# UNITED STATES PATENT AND TRADEMARK OFFICE

<b>Office Action Summary</b>	<b>Application No.</b> 10/565,802	<b>Applicant(s)</b> METTAVANT, BENJAMIN	
	<b>Examiner</b> Winnie Yip	<b>Art Unit</b> 3636

### **DETAILED ACTION**

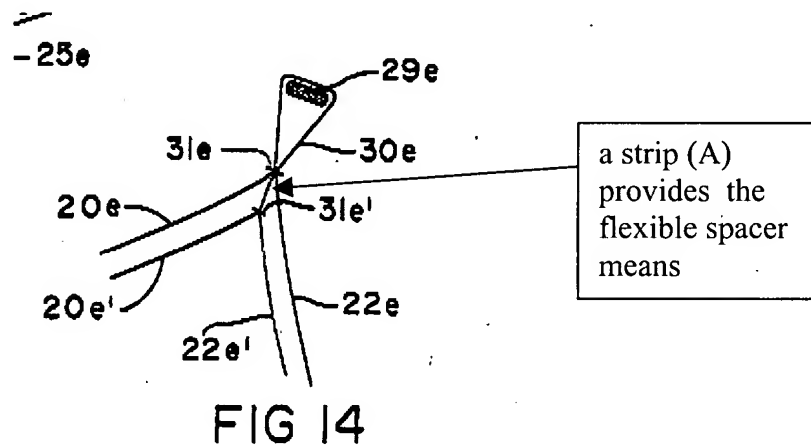
Norman teaches a self-deployable tent comprising: a hoop structure (see Fig. 14) including at least one top loop (29 or 29e) connected to a base (26), the base (26) being a ground sheet, a

roof sheet (20, 22; or 20e) secured to the top loop (29 or 29e) and the base sheet (26), the roof sheet (20e) having a long strip of material (30e) fixed on and integrated in the outside face of the roof sheet (20e) to allow the top loop (29e) passed therethrough, an inside chamber (20e') disposed beneath the roof sheet (20e), a flexible spacer means (a strip A formed by stitching 31e and 31e') provided between the roof sheet (20e) and the bottom chamber (20e'), wherein the inside chamber (20e') has a top portion secured to the top loop (29e) via the flexible spacer means (31e) and a bottom portion attached to the ground sheet (26) (see col. 5, lines 8-16), wherein in the deployed position, the tension of the roof sheet and the inside chamber are held apart from each other by the flexible spacer means, the bottom portion of the roof sheet includes two opposite openings (32) for inlet and outlet of air flowing in a ventilation space between the roof sheet and the inside chamber. Although Norman does not define the hoop structure including a base loop as claimed, Habchi teaches a tent comprising a hoop structure including a top loop (12) having two ends being connected to a base loop (11), the base loop being attached to a ground sheet, a roof sheet (24) attached to the top loop and the base loop, and the top and base loops having connectors for providing adjuster means that can adjust the width of the tent. It would have been obvious to one ordinary skill in the art at the time the invention was made to modify the self-deployable tent of Norman having a base loop being connected to the top loop and covered by the ground sheet and with the loops having adjusting means as taught by Habchi for providing an adjustable tent with a base support in a self-deployed position.
